VILLAGE OF TWIN LAKES

PLAN COMMISSION MEETING

Wednesday, March 1st, 2023 at 6:30pm

TO: Plan Commission
Village of Twin Lakes

Figure 4: Revised Side Elevations (Source: Applicant – 1/12/23)

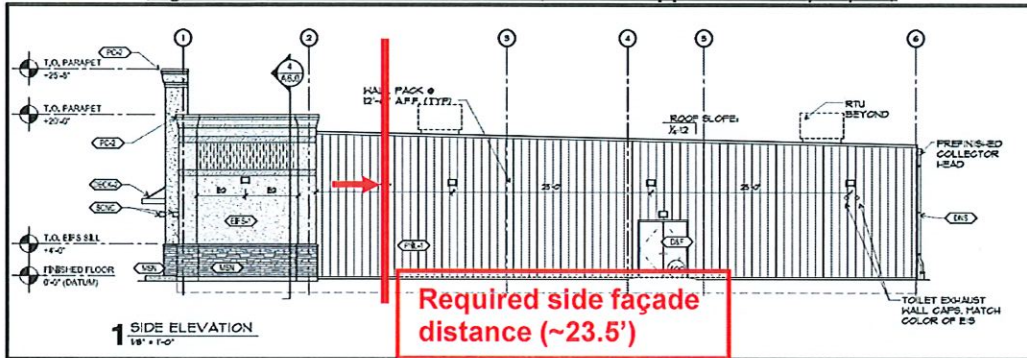
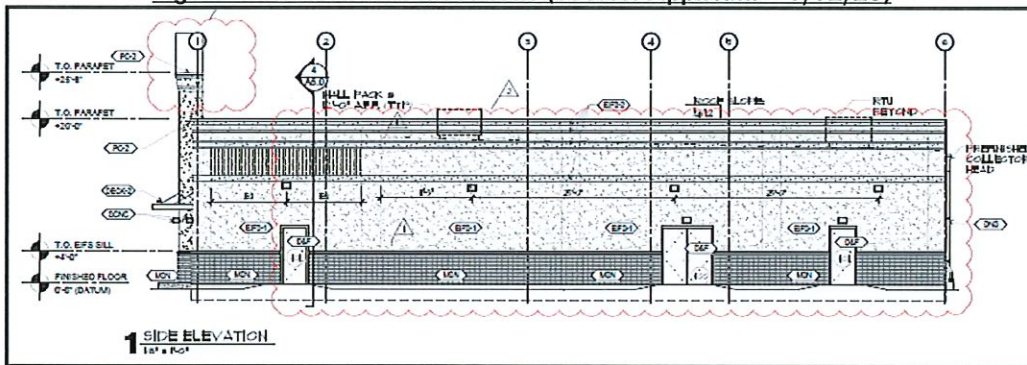
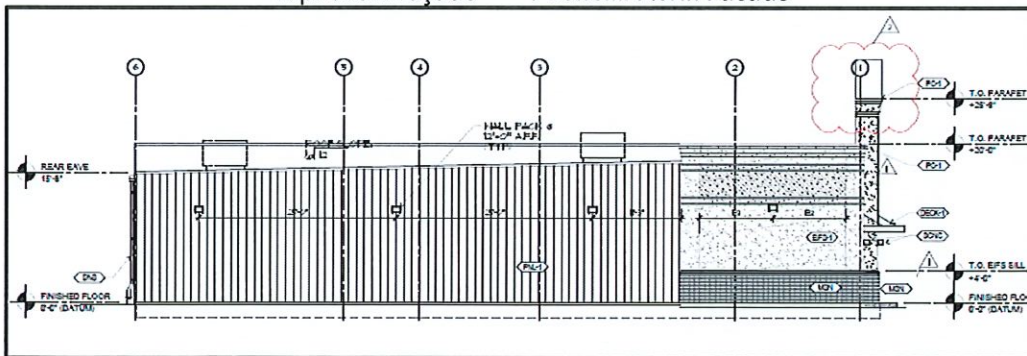
- i. The Applicant has revised the plan to replace the adhered masonry veneer with face brick veneer in a red color to match adjacent buildings. The synthetic stucco material comprising the majority of the façade remains. (See Figure 2)
- ii. The Applicant has extended the proposed façade materials the entire length of the southern side façade and to one-fourth (1/4) of the northern façade. (See Figure 4)

- A. Buildings: Façade Dimensions - The Applicant proposed a design which did not meet façade length requirement for the side facades of the building.
 - a. Applicant shall revise the elevation in the architectural plan to extend façade materials a minimum distance equal to one-fourth (1/4) of the side dimension.

- i. The Applicant has revised the side facades to the entire length of the southern façade and one-fourth (1/4) the length of the northern façade.
- B. Buildings: Architectural Consistency and Coherence - Staff recommended four options to revise the design of the façade, included below:

Figure 5: Previous Façade (Top) and Revised Façade (Bottom)

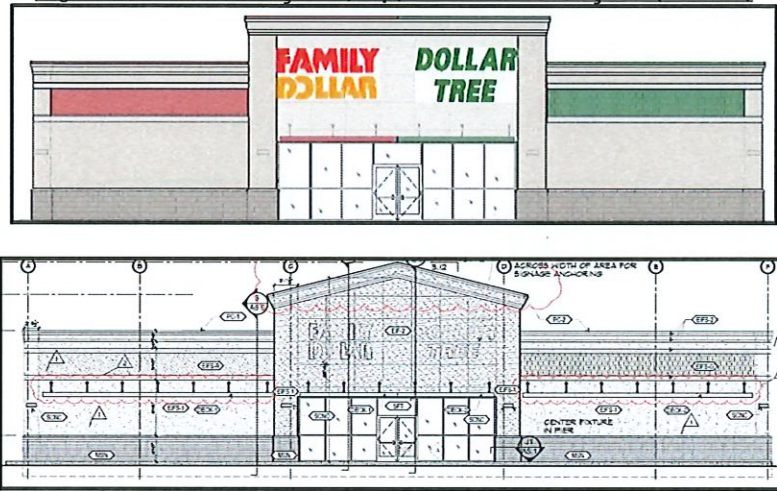
- a. Façade shape: The Applicant has revised the shape of the façade to a gable/sloped roofline. (See Figure 5)
- b. Fenestration and massing: The Applicant has revised the column details by removing the stripes of material changes across. (See Figure 6)

- i. Red brick veneer has been integrated into the lower portion of the façade in place of the previous masonry veneer proposed.
 - d. Applicant should revise the roofline to a gable design more compatible with its surroundings.

- i. The Applicant has revised the design to include a gable roofline.
- C. Buildings: Visibility from the Street – The Plan Commission did not identify additional façade requirements on the northern façade.

Figure 6: Previous (Left) and Revised (Right) Column Details

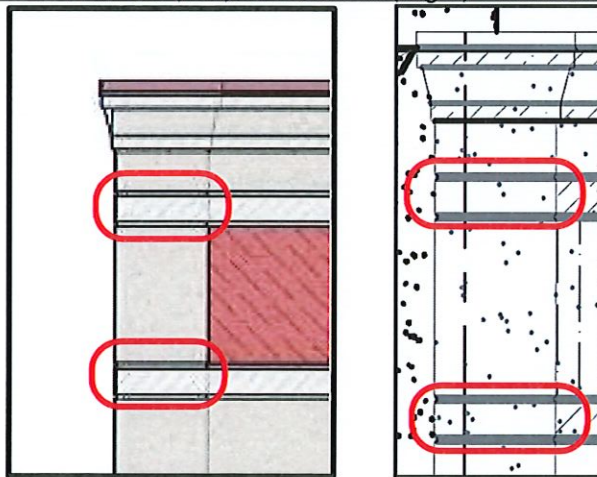
- a. Applicant should remove the stripes across the column details to distinguish them from the rest of the façade design; and/or
 - i. The Applicant has revised the design to remove the stripes across the column details.

Figure 7: Proposed Landscape Design (Source: Seeding Plan – 1/25/23)

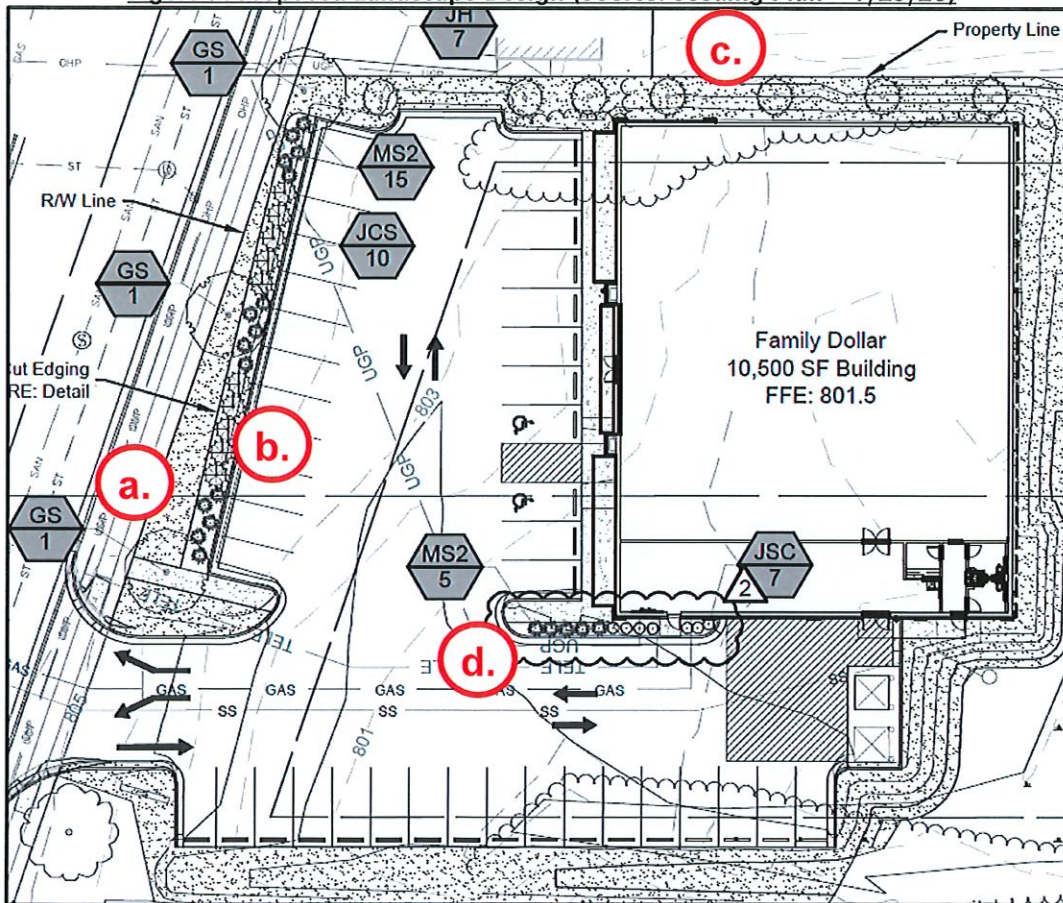
- D. Landscape: The Applicant previously proposed a landscape plan consisting entirely of turf and one preserved tree on the property. (See Figure 7)
- a. Street Trees: The Applicant has revised the design to include three (3) Honey Locust street trees behind the sidewalk on North Lake Avenue.

- b. General landscaping: The Applicant has revised the design to include a series of ten (10) sea green juniper shrubs and twenty (15) Maiden Grass shrubs along the western parking lot edge in an approximately four and a half (4.5) foot deep planting bed.

- c. Landscape buffer: The Applicant has revised the design to include a series of seven (7) evergreens with a six (6) foot height minimum on the northern property edge to buffer the adjacent building.

- d. Foundation plantings: The Applicant has revised the design to include foundation plantings as screening for the loading area on the southern façade consisting of seven (7) Skyrocket Junipers with a six (6) foot height minimum and five (5) Maiden Grass shrubs in the front.

- a. The Applicant shall submit a revised landscape plan including street trees, trees, ground cover and shrubbery in the front setback area and unpaved areas.

- i. The Applicant has revised the design to include all recommended landscaping.
